PROPOSED MERCEDES BENZ DEALERSHIP

MONTGOMERY AUTO SALES PARK - LOT 11

CORRIDOR 1
CHECK IMPACTS TO
MONTGOMERY AUTO
SALES PARK REDEVELOPMENT

RE: Preliminary Plan #1-04106
Montgomery Auto Sales Park

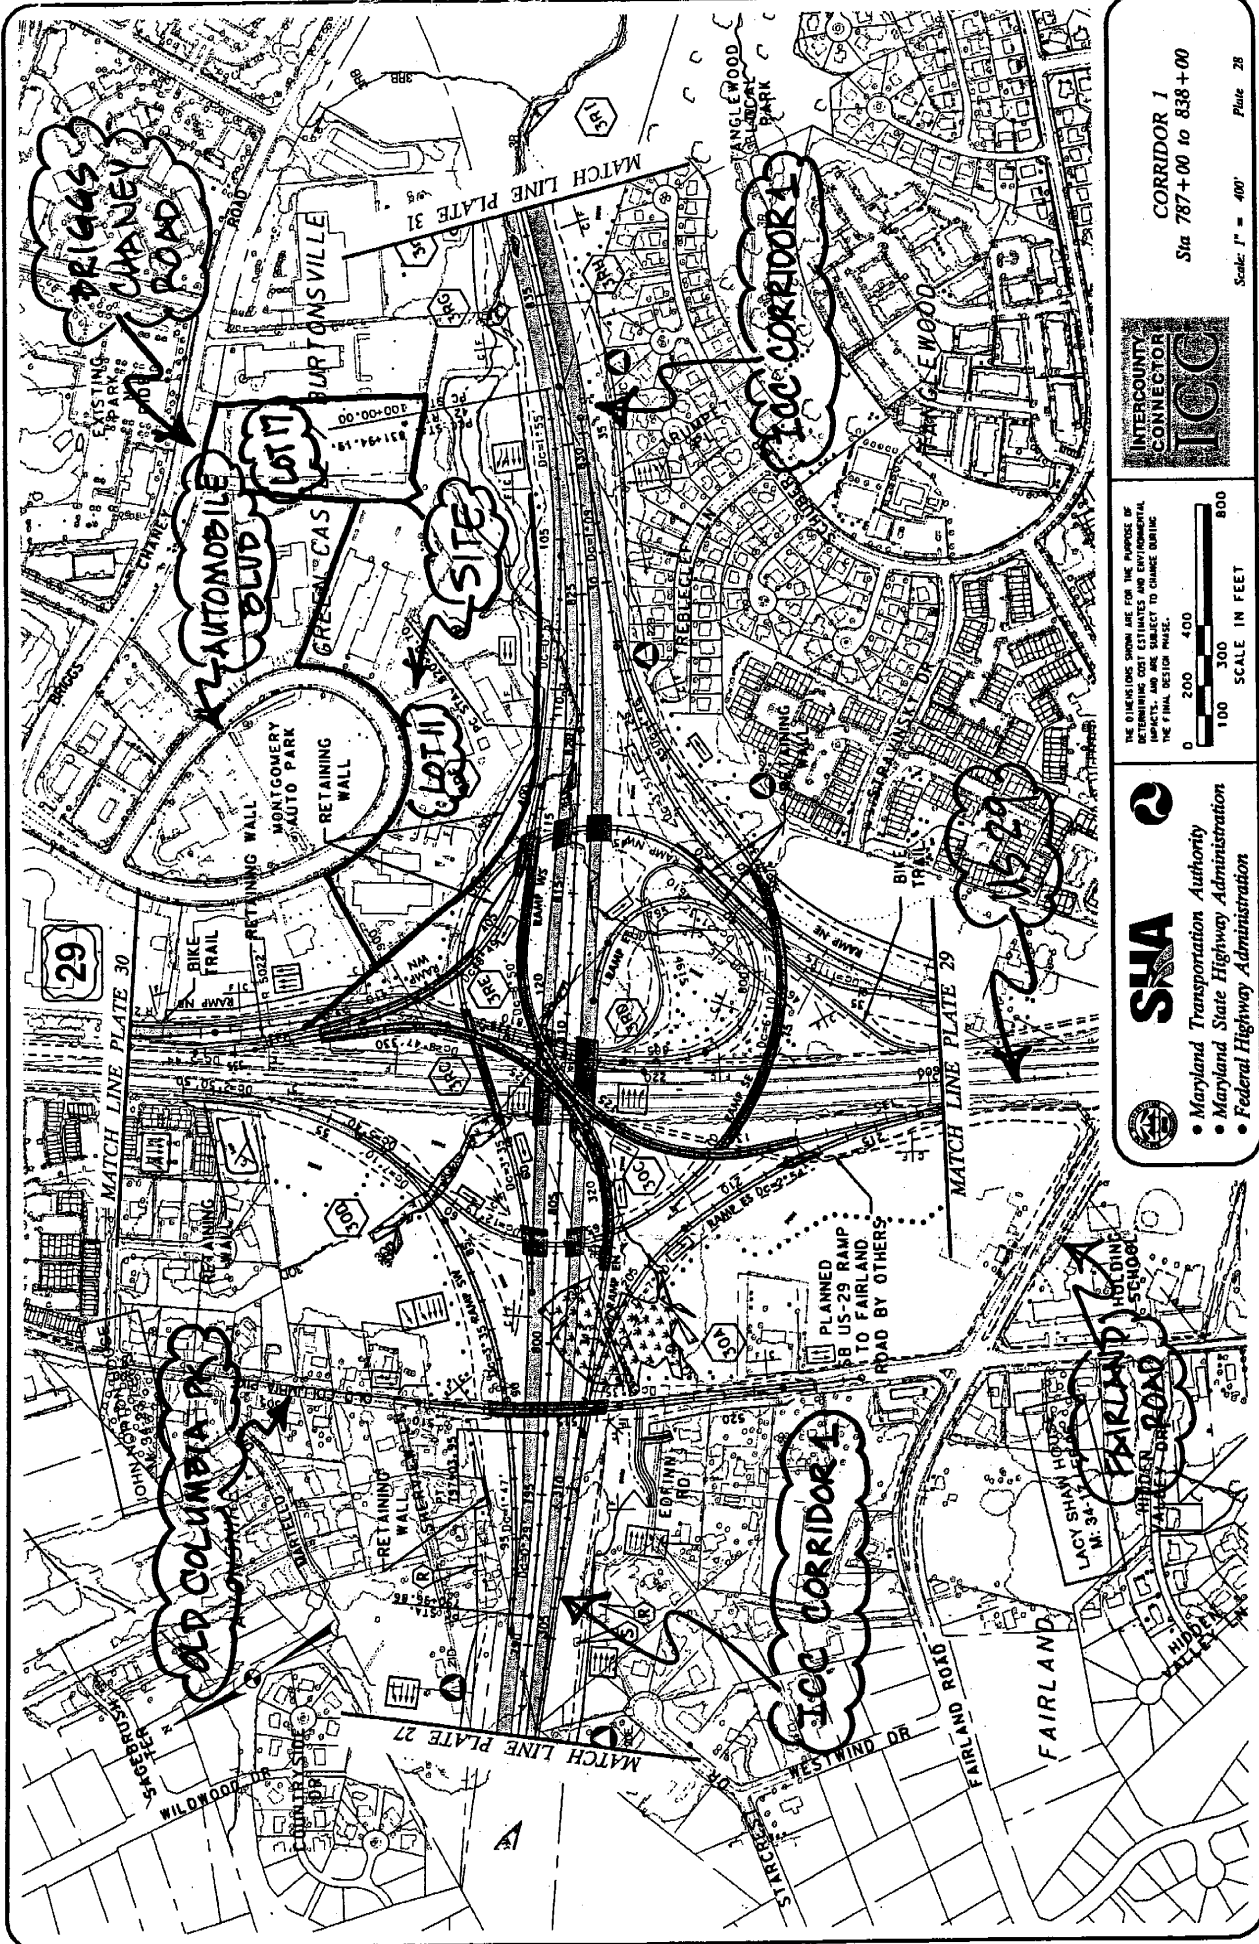
POTENTIAL NEW RETAINING WALL LOCATION

AREA WHERE WALK WOULD BE REQUIRED TO BE IN BY AUTO-DEADEND - 406
